FARRAGUT MUNICIPAL PLANNING COMMISSION

AGENDA

September 16, 2021

NEW ADDITION - SECOND FLOOR PLAN
A103 1/8"=1'-0"

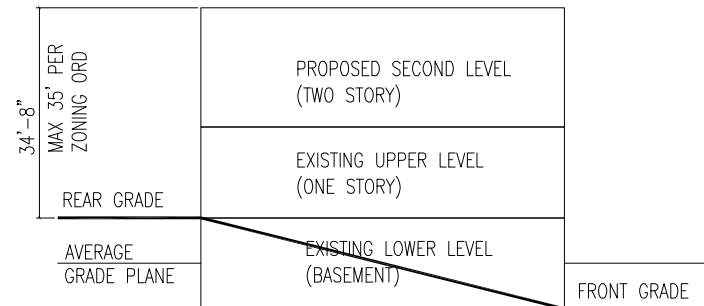
DISCUSSION: During the staff/developer meeting on August 31, staff reviewed some discussion items, including compliance with the 75% masonry requirement for the net façade area of the building and whether enough parking was available to accommodate the proposed addition. The applicant has revised their initial building elevations to satisfy the masonry requirement. In terms of parking, the campus exceeds the amount of parking required based on the sanctuary space of the church. There are 1,338 parking spaces provided on the campus and 1,045 parking spaces that would be required based on the size of the sanctuary. Though the educational building is removed from the sanctuary and parking allocations have been provided based on the sanctuary size, due to the offset time of use between the school and the church, the applicant and staff are comfortable with the amount of parking available and would agree that no additional parking should be needed.
